Historic Resources

Draft Environmental Assessment
Proposed Airport Traffic Control Tower and Associated Improvements at BWI Marshall Airport

Attachment to
Project Review Form
for
BWI Marshall Airport Traffic Control Tower
Replacement and Obstruction Removal
Anne Arundel County, Maryland

**VIEWSHED ANALYSIS FOR PROPOSED NEW
AIRPORT TRAFFIC CONTROL TOWER,
BALTIMORE/WASHINGTON INTERNATIONAL
THURGOOD MARSHALL AIRPORT,
ANNE ARUNDEL COUNTY, MARYLAND**

Figure 3: Final viewshed generating using digital surface with current conditions

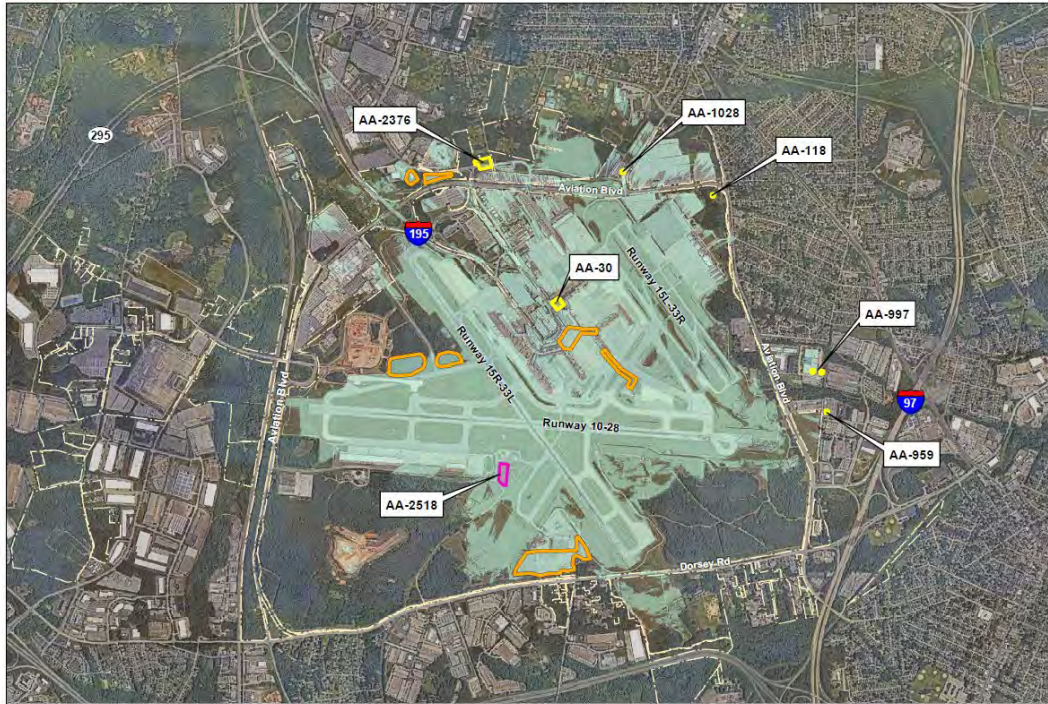
1. The Viewshed Analysis says that "Of these properties, only one falls within the current viewshed for the ATCT: the Airline Cargo Building, from which the current ATCT is visible. As such, the new ATCT will not result in any new effects to this building." *Should the Airline Cargo Building be shown on Figure 3 of the Viewshed Report? I'm wondering if it could be the circled building (highlighted aqua) and just didn't get labeled?*

- Added Airline Cargo Building label to the aqua outline in Figure 3 of the Viewshed Report. EAC/A's analysis noted that the building falls within the proposed ATCT's viewshed as well as the viewshed of the existing ATCT, so now it is labeled which makes better sense with the narrative/text.
- Added AA-2518 Friendship Cemetery to the figure and the narrative updated. As you can see from EAC/A's Principal Investigator (Rob Warner) they deliberately left it off because by "our definition it is not a historic property since it has been determined not eligible for (nor listed on) the National Register." However, he added some additional language and included the cemetery in their figure so that no one else wonders if it's an oversight (as we did).

I am very sorry that I am only getting to this now - we had several projects pop up and I have been in and out of the office. In the attached document I have addressed both of the concerns. I did deliberately leave out Friendship Cemetery because by our definition (in the first paragraph) it is not a "historic property" since it has been determined not eligible for (nor listed on) the National Register. However, I've changed some of the language and added the cemetery to the images so that no one gets the impression that this is an oversight. I'm sending an additional pdf showing where edits were made on the first page. Please let me know if you have any other questions or concerns and I promise I will get back to you quickly!
